# STAFF RECOMMENDATION

NCPC File No. 6433

**U. S. NATIONAL ARBORETUM**  
REVISED PLAN FOR MODERNIZATION OF HEADHOUSE/GREENHOUSE  
3501 New York Avenue, NE, Washington, D.C.

June 29, 2006

**PROJECT FINAL BUILDING PLAN INDICATING LOCATION OF WALKWAY AT LEFT AND COVERED CANOPY SECTIONS AT RIGHT**

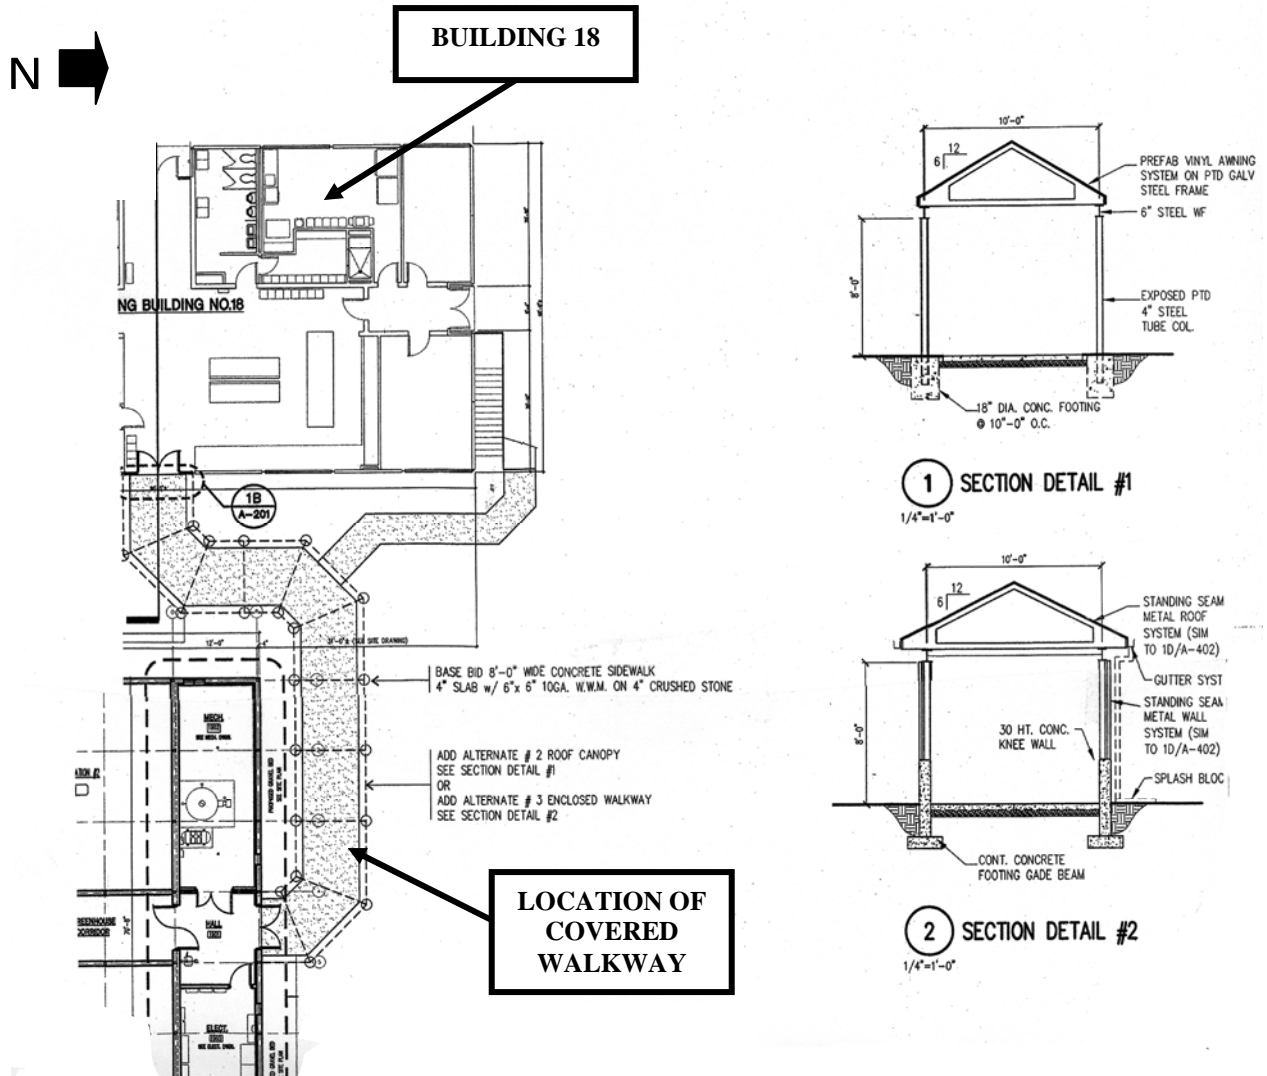
The new greenhouse structure will remain as previously approved by the Commission in 2004 but an exterior connecting corridor from Building 18 to the greenhouse is now being submitted as a revision. Accessibility would be enhanced by a new covered sidewalk and requires minimal space reduction of the headhouse area only. The exterior canopy materials are completely utilitarian in composition and are limited to a length of just 85 feet. The new connecting corridor will be either an open-sided vinyl canopy or, as an option, the same prefabricated exterior standing seam wall as the new greenhouse, set on a hip-high knee wall with a gray standing seam roof.

**Staff recommends approval** of the revised final site and building plans. The modified project, which involves less than 800 square feet of revised building area, would have no adverse impact on land uses or environmental resources of the general site. The proposed project plans are in conformance with the master plan location for the facility and no other changes are proposed.

The Commission **approves** the revised final site and building plans for a new modified headhouse and greenhouse for the U.S. National Arboretum, including a connecting covered walkway, as shown on NCPC Map File No. 43.20(38.00)-42050.
